Notice of Allowability

10/775,851

Anjan K. Deb

PONZIANI ET AL.

FIG 19A

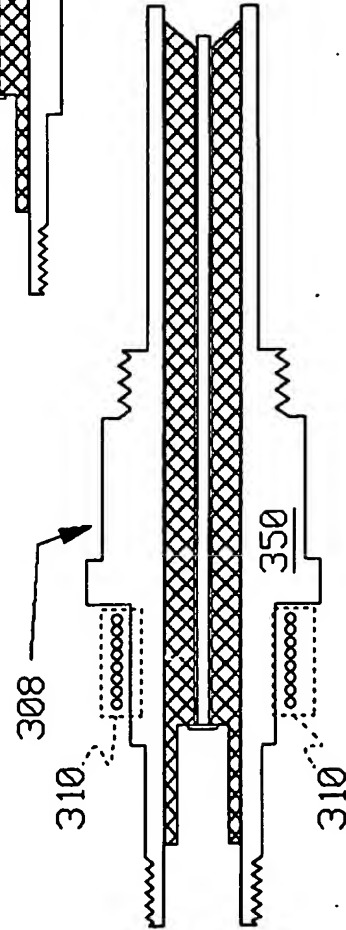
In the drawing, Fig. 19 A, added reference numeral 311 (see attached drawing correction).

Approved
 A Deb
 5/30/2006
